Re: Building Permit #020212 , Rear Stairs @ 116 Revere St.(129 J009)

The waiver request for the intermediate rail and guardrails have been reviewed pursuant to Section 121. of the City's Building Code and the request has been granted with the following condition:

116 LEVERNE STREET

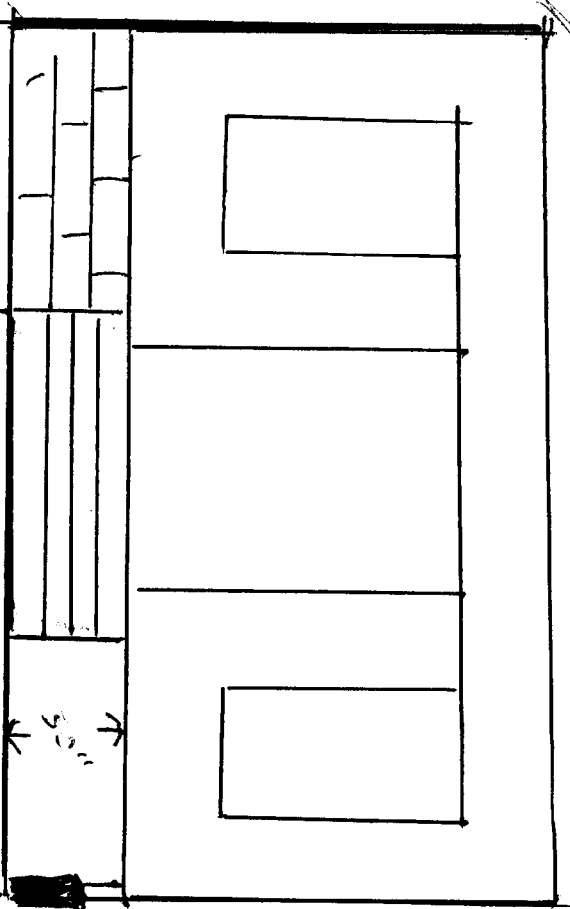
As discussed yesterday, the requirement to have a center guard/hand rail on steps greater than or equal to 60 inches wide presents a hardship, as we would not be able to use the screen doors – the center guardrail would interfere with their use.

We are also requesting a variance to the requirement for guard/hand rails on the sides of the steps, which will be low – 28 inches from the floor to the ground. We plan to put large pots on ends of the steps, which will have three treads - the top tread 21 inches from the ground. Again, because of the shallowness of the yard before the hill starts and large trees close to the house, three foot guardrails on each side of the steps will create a structure that is boxed in and not in harmony with existing, permanent landscape design.

- That a 36" guardrail be constructed on the right of the doorway as it is faced from the rear of the structure. The Guard will have openings less than 4" and shall measure 36" from the leading edge of the stairs.
